MEMORANDUM

SUBJECT: Consideration of Design Review, Maplewood Auto Mall, 2529 White Bear Avenue

Engineering Plan Review

Environmental Review

1 ROOF AND SITE PLAN
SCALE: 30' = 1'-0"

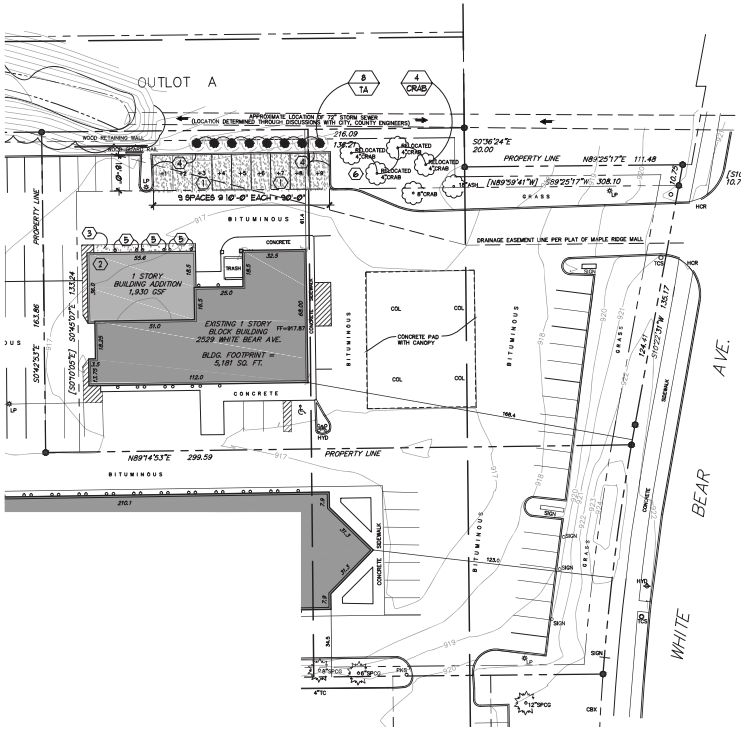
Most landscaping will be undisturbed by this project. The four trees that will need to be moved to accommodate the parking spaces will be relocated east of the parking lot expansion. The applicant's plans indicate 12 new shrubs would be planted, but only eight are visually represented on the site plan. The applicant has stated the intention is to plant eight shrubs. The area around the nine new parking spaces will be re-sodded once construction is complete.

The applicant is proposing to construct an addition to the existing building at 2529 White Bear Avenue. In order to accommodate customer parking for this additional space, the applicant is also proposing to create 9 new parking spaces along the northern property line. As the disturbance on this project appears to be under ½ - acre, and there is less than 5,000 square-feet of new impervious surface proposed, the project will not be subject to the City's water quality improvement standards.

5) Mitigation for the proposed parking lot addition could be achieved via the use of pervious pavement, the installation of rain gardens, or the replacement of existing pavement with green-space; to name a few options.

7) The applicant shall detail proposed elevations surrounding the building and new parking areas. All new site improvements shall be ADA compliant.

A. **Wetland Ordinance:** The wetland ordinance requires a 75 foot buffer from a Manage B wetland. The existing parking lot is constructed to within 15 feet of the wetland and is considered a pre-existing nonconforming parking lot. The applicant is proposing to expand the parking lot with the existing setbacks. City code allows an applicant to expand a nonconforming parking lot if the parking lot meets the following conditions:

Wetland Recommendations: Expansion of the parking lot meets the conditions outlined in City code for the expansion of a nonconforming parking lot. Therefore no wetland buffer variance is required. However, the City should ensure that runoff from the parking lot does not adversely affect the adjacent property and Manage B wetland. Prior to issuance of a permit the applicant shall:

B. **Trees Ordinance:** There are four 4-inch crab apples trees which will be removed and relocated on the site with the parking lot expansion. The applicant is also proposing to plant 8 techny arborvitae shrubs on the north side of the expanded parking lot.

The City's tree ordinance requires replacement of significant trees. Significant trees are defined as deciduous trees that are 6-inch diameter or larger, conifers that are 8-inch diameter or larger, and softwoods that are 12-inch diameter or larger. The relocation of crab apple trees does not require tree replacement according to the City's tree ordinance. But the City should review the landscaping on the site as part of the design review.

2. The applicant's proposed addition to the parking lot shall not be any closer to the north property line than the setback established by the existing parking lot.

4. The additional parking spaces shall be striped per ordinance requirements.

1. Submit revised plans which show the mitigation of the parking lot. Proposed mitigation strategies include:

a. Use of pervious pavement
b. Installation of rain gardens
c. Replacement of existing pavement with green-space

2. The applicant shall submit a cash escrow or letter of credit to cover 150% of the parking lot mitigation strategy.

1. Submit a cash escrow or letter of credit to cover 150% of the tree relocation and landscaping.

2 NORTH ELEVATION
SCALE: 1/8" = 1'-0"

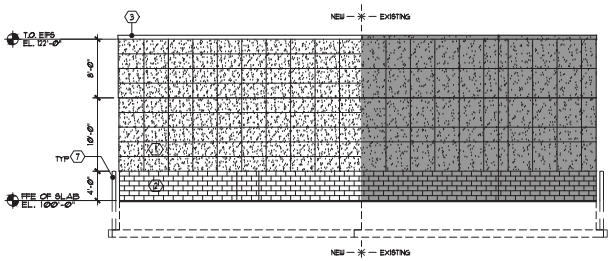
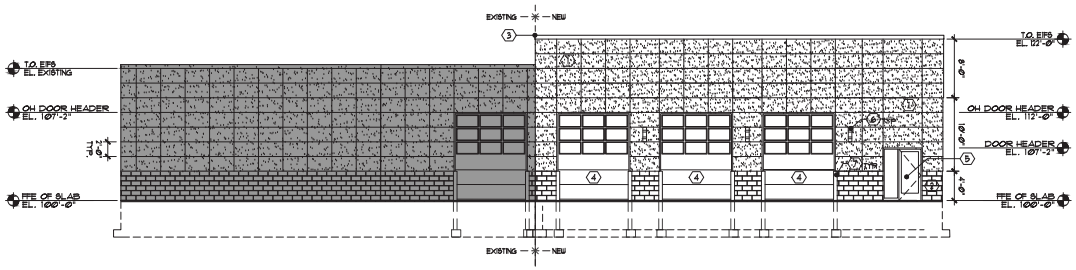
The addition will utilize the same materials as the existing building to provide a cohesive look. The north elevation exterior will have EIFS paneling and 3 metal overhead doors.

The entire exterior will be painted with a tan color to match the current building and the adjacent buildings.

3. The building materials and colors used for the building addition shall match the materials and colors for the existing building.

2529 Parking Plan

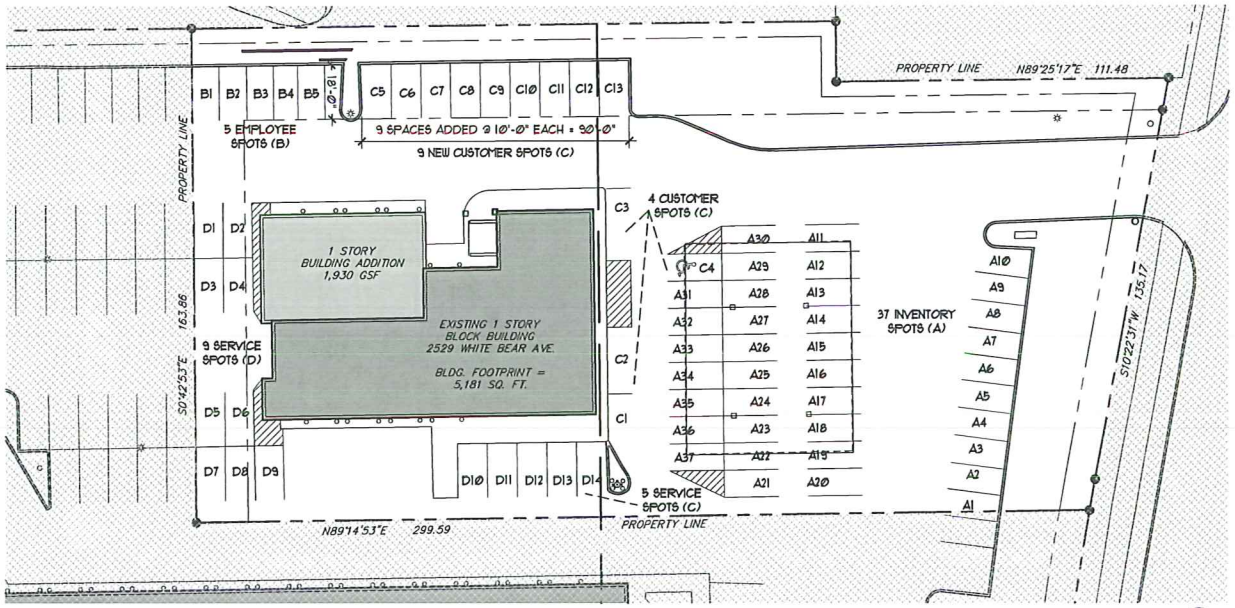
City ordinance requires motor vehicle repair shops to have two spaces for each service stall, one space for each employee, and one space for each business vehicle stored on site. The applicant is not adding staff or vehicles with this proposal so the required additional parking is six spaces. This property also shares parking with the adjacent auto center.

17. All tenants at the Maplewood Auto Center must adhere to the parking plan, dated ~~July 8, 2013~~ <u>November 17, 2015</u>, as submitted by the property owner to city staff. A parking plan needs to be filed with city staff at all times indicating the property is meeting the minimum parking requirements and how the spaces are allocated to each tenant. A new parking plan shall be filed any time a suite changes use or the building is physically altered in any way.
